4.2 SAS-2 S-Parameters of Cable Assemblies and Backplanes ([08-187r1](#)) [Olawsky]

4.7 SAS-2 letter ballot comment updates for transmitter and receiver tables ([08-202r0](#)) [Cox]

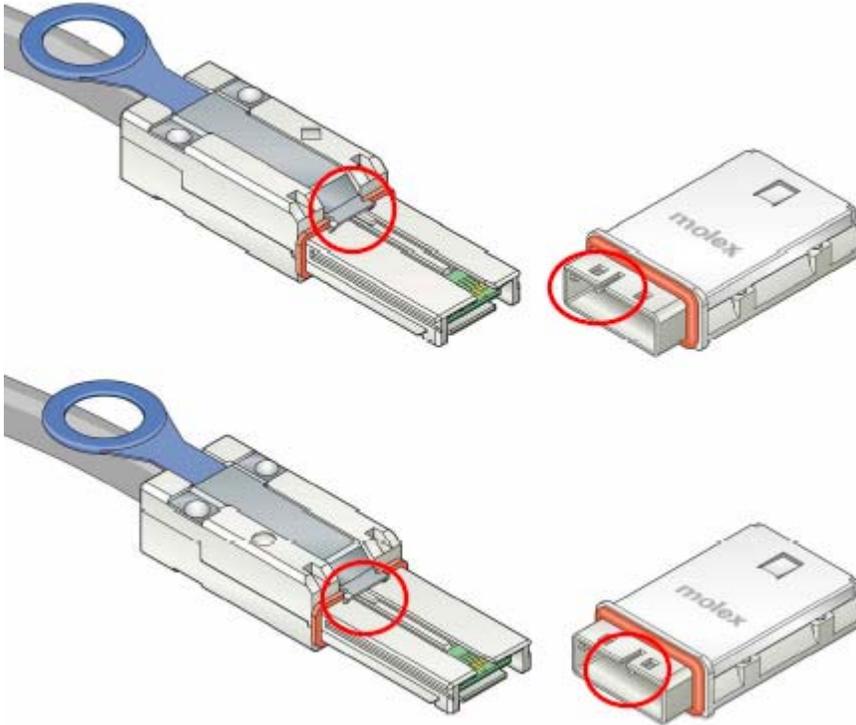
4.3 Propagation delay

The STP flow control budget (sas2r14 section 7.17.2 note 77) assumes 5 ns/m prop delay on a cable. For 10 m, this means:

- one-way prop delay 50 ns
- round-trip prop delay 100 ns
- $26 \frac{2}{3}$ ns per dword at 1.5 Gbps
- $100 / 26 \frac{2}{3} = 3.75$ dwords on the wire at 1.5 Gbps
- $100 / 26 \frac{2}{3} * 2 = 7.5$ dwords at 3 Gbps
- $100 / 26 \frac{2}{3} * 4 = 15$ dwords at 6 Gbps

We use that to justify a buffer size of 4 dwords at 1.5 Gbps, 8 dwords at 3 Gbps, and 16 dwords at 6 Gbps.

However, <http://www.spectra-strip.amphenol.com/ecpartsearch3.cfm?partID=366> says an Amphenol Spectra-Strip cable has 5.1 ns / m nominal propagation delay, longer than our assumption.

What is a good worst-case propagation delay number to use?

If it were 5.3 ns, then we'd be right at the budget:

$$5.3 / 26 \frac{2}{3} = 3.975 \text{ dwords at 6 Gbps}$$

$$5.3 / 26 \frac{2}{3} * 4 = 15.9 \text{ dwords at 6 Gbps}$$

Worst than 5.3 means our budget is not big enough.

We should probably add a rule in chapter 5 that a SAS cable (or any interconnect) must have a total propagation delay of less than 50 ns (or 53 ns... whatever matches note 77).

Solution:

Add the following in the TxRx requirements section and add pointer in the cable backplane section to it:

To support STP flow control minimum buffer size implementations, the total propagation delay of the TxRx connection shall be less than 53 nS.
